From: [Karen Hamilton \(Brodies Solicitors\)](#)
To: [Hornsea Project Three](#)
Subject: Hornsea 3 - Spirit Energy - Responses to ExA Questions of 19.12.18 [BRO-D.FID4510103]
Date: 15 January 2019 23:55:50
Attachments: [image013.png](#)
[image014.png](#)
[image015.png](#)
[image016.png](#)
[image017.png](#)
[image018.png](#)
[Scan-to-Me from gowan.local.brodies.co.uk 2019-01-15 224746.pdf](#)
[Spirit Energy Appendix - C6 Spreadsheet.pdf](#)
[Spirit energy - Draft Responses to ExA Qs dated 19 December 2018 - 15 January 2019 44259658_14.pdf](#)

**HORNSEA PROJECT THREE OFFSHORE WIND FARM DCO
OUR CLIENTS: SPIRIT ENERGY NORTH SEA LIMITED; SPIRIT ENERGY RESOURCES LIMITED; SPIRIT
ENERGY NEDERLAND B.V.**

SPIRIT ENERGY

RESPONSES TO EXAMINING AUTHORITY'S QUESTIONS OF 19TH DECEMBER 2018

Figure 1 – Showing possible routes that can be taken by vessels in a westerly gale

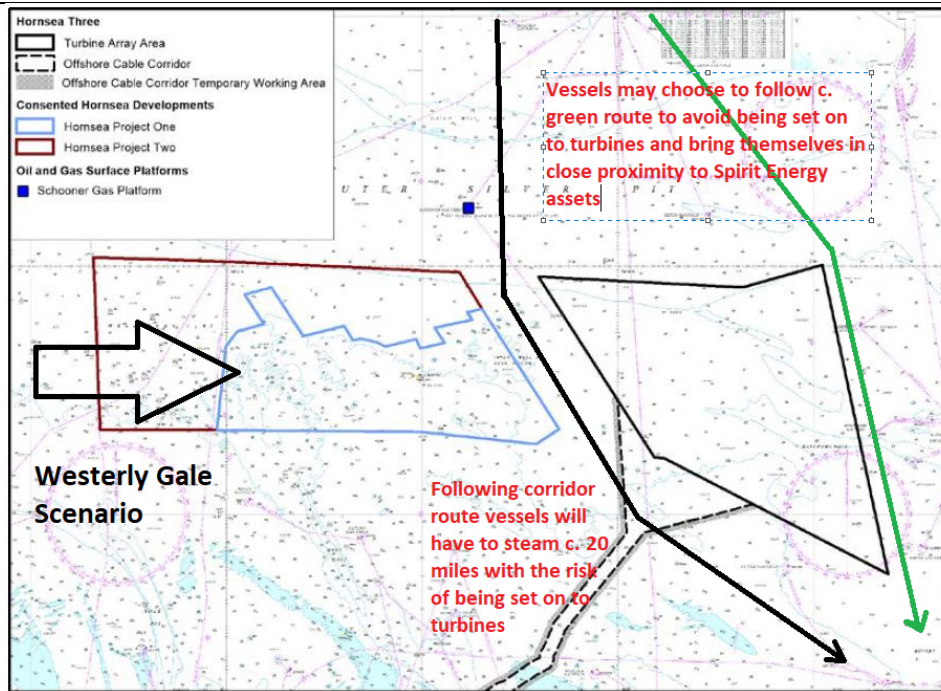
The situation summarised by the ExA is not limited to periods of westerly gales (namely Force 8 on the Beaufort Scale or 17 to 21 metres per second) - see Figure 1 below.

Whenever the wind is from the west, vessels may prefer to follow this track to avoid the risk of drifting into the array (e.g. should they experience a loss of power).

Passing through the channel would involve running along a long line of turbines (approx. 20 miles) immediately to the east on to which they would be set by the prevailing wind.

Given the range of factors which may influence choice of route, it is considered possible that masters of vessels may choose to follow the track shown by the green arrow in Figure 1 at any time. The information currently made available by the Applicant on displacement is not considered sufficiently robust to rule this out.

Figure 2: Illustration to show requirements for vessels in relation to Traffic Separation Schemes: International Regulations for Prevention of Collisions at Sea

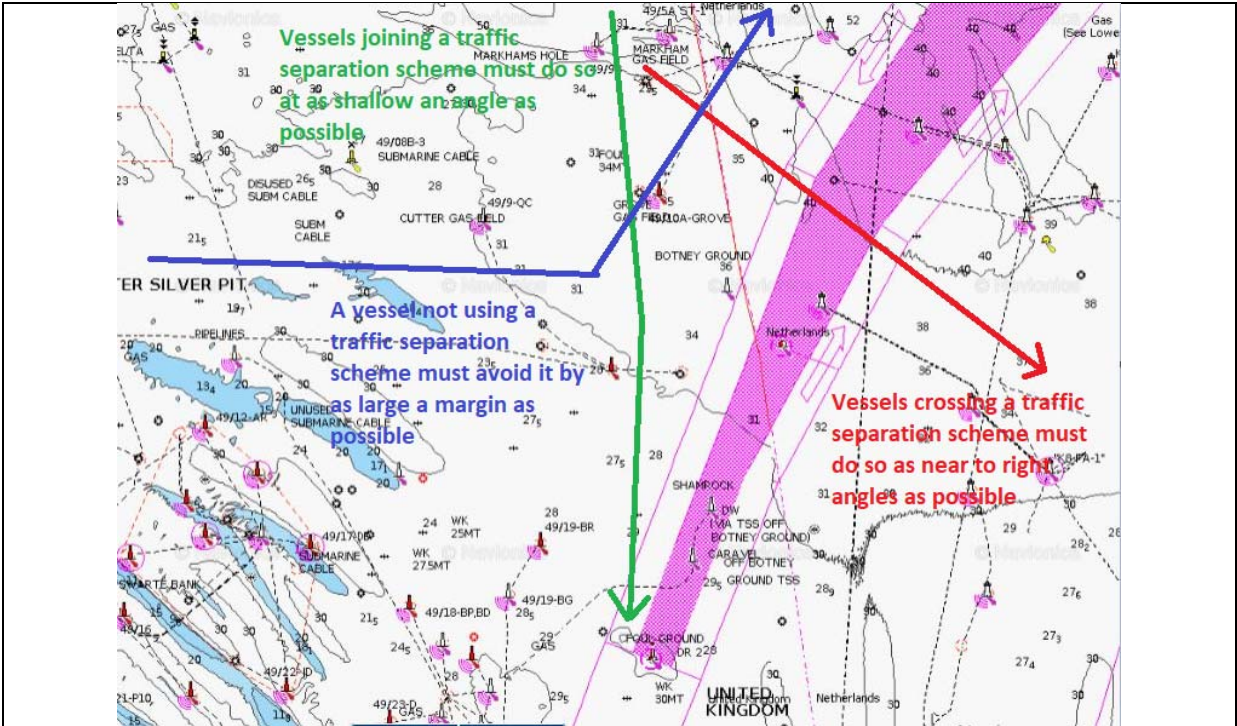
Figure 2 illustrates how vessels routing to the east of the Array (as shown by the green arrow in Figure 1) may interface with the Traffic Separation Scheme "Off Botney". For example, vessels heading to Antwerp may join the Traffic Separation Scheme at an appropriate angle (green arrow, Figure 2) while vessels crossing the Traffic Separation Scheme may do so along the route indicated by the red arrow on Figure 2.

Figure 4: Annual Wind Rose extract from metocean data for the area[to be revised]

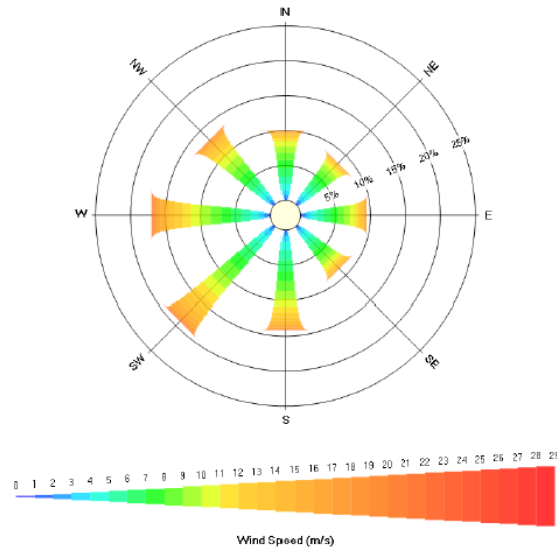
Figure 4 is extracted from the Block 6a of the Metocean Data (relied upon by DNV GL having been provided by Spirit Energy. The data was prepared on Spirit Energy's behalf). It summarises wind speeds and directions on an annual basis. It can be seen from the diagram in Figure 4 that the predominant wind directions are from the west and south west (from which the wind blows approximately one third of the time, which is significant) giving rise to the conditions where vessels passing between the arrays may be set down onto the Hornsea 3 array and may then choose to pass to the east of the array. However, Figure 4 does include considerable seasonal variation as discussed in the Response to Question 2.5.9 below.

The risk posed by a drifting construction barge would be worse in winds from the south west / west i.e. the predominant wind directions, as illustrated by Figure 4 – wind blows from the west/south west approximately one third of the time. In such circumstances, at around four knots drift speed, a drifting barge would drift to Chiswick and or Grove in between thirty to forty minutes. No tide has been allowed for. Where the tide is working with (rather than against) the drifting barge, the effect of the tide may be to add another 1 to 2 knots to the speed of the drifting barge.

Figure 5: Illustration to show possible vessel tracks during Northerly Gales

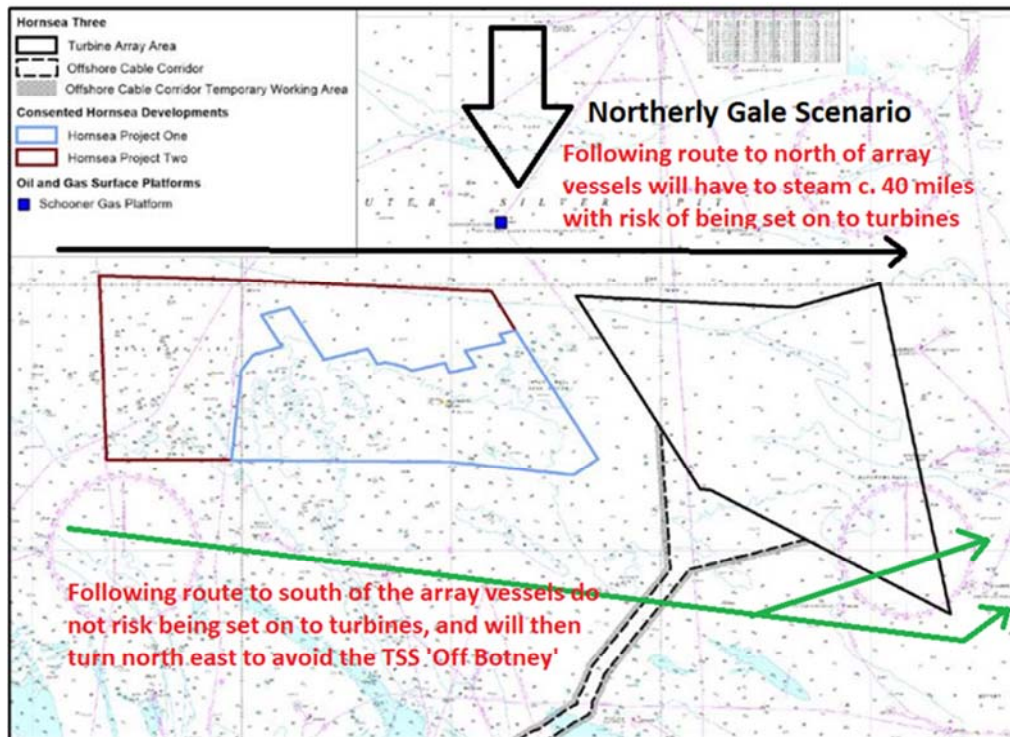
The situation is not limited to periods of northerly gales (namely Force 8 on the Beaufort Scale or 17 to 21 metres per second) – see Figure 5.

Whenever there are northerly winds, vessels passing to the north of the array would be at risk of drifting into the array. By passing south of the array, vessels would avoid running along a long barrier of turbines (c. 40 miles) on to which they would be set by the prevailing wind. The two green arrows on Figure 3 illustrate routes which masters might reasonably take to avoid the Traffic Separation Scheme – in both instances bringing the vessel in close proximity to Grove. This situation would be exacerbated in the event of a loss of power.

Figure 5A: Seasonal wind rose extract for the area for June

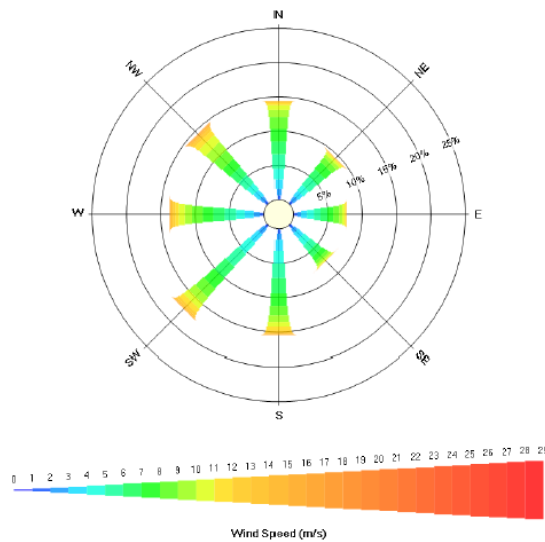
Despite the predominant winds being from the west/south west, the wind rose depicted at Figure 5A illustrates the seasonal variations which can and do occur, with northerly winds being more frequent than usual in June (approximately 15 per cent of that month). This frequency is considered important. However, it should be noted that these presentations are long term averages and that periods of exceedance can occur at any time, from any direction.

Figure 11: Sectional Diagram showing safe Missed Approach Distances

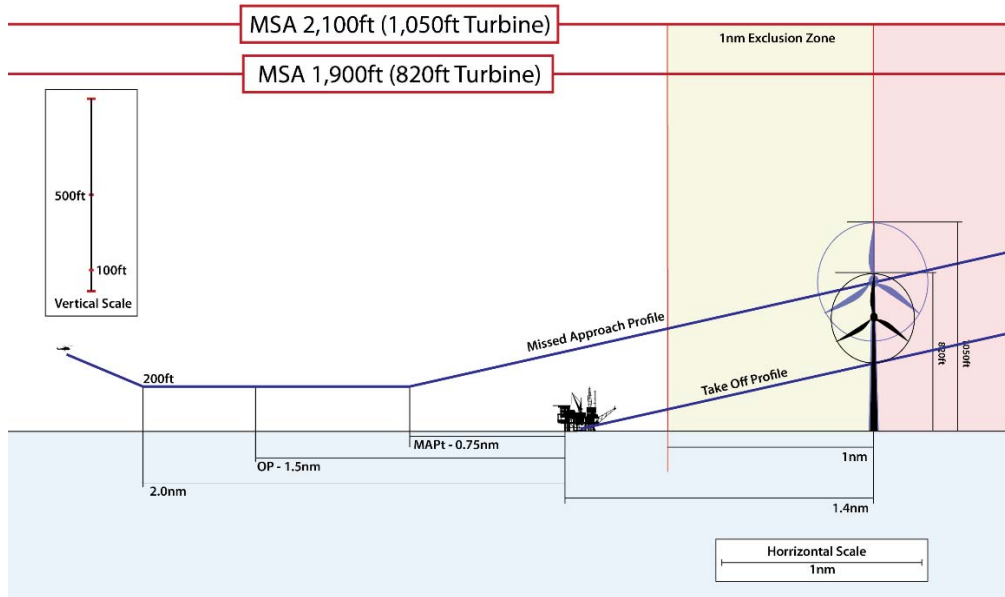
Indicative ARA to Chiswick Platform Showing OEI Missed Approach Profile & OEI Take Off Profile
 EC155B1 - WV270/17kts - Climb Rate 420ft/min @ 75kts IAS

Figure 12

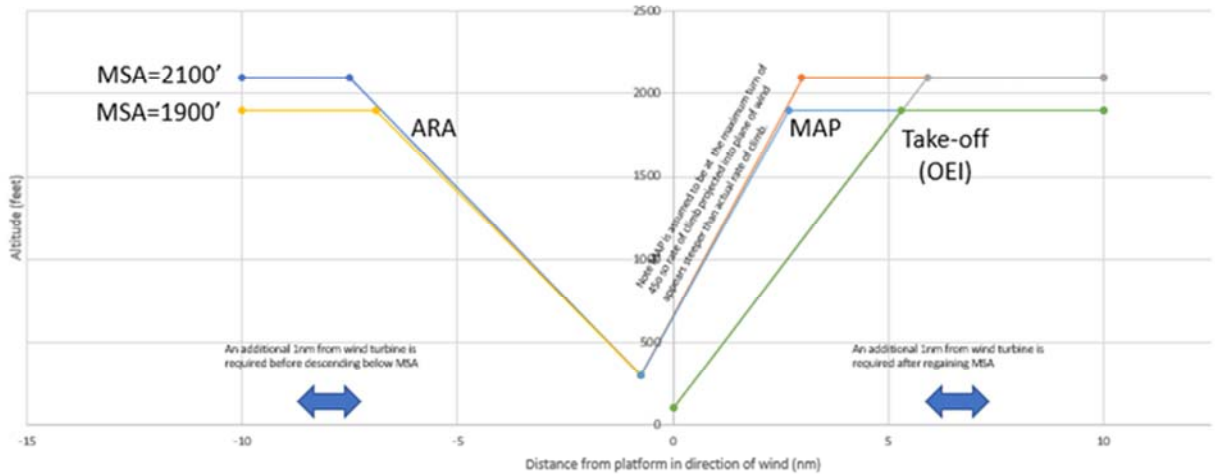
Descent and Ascent to/from Chiswick for two Turbine heights (325m and 250m)

Figure 12 shows the approach, missed approach and take off as a cross section in the plane of the wind direction for two turbine heights given by the Applicant. Since approach and landing are both into the wind there needs to be adequate unobstructed airspace upwind and downwind of the platform.
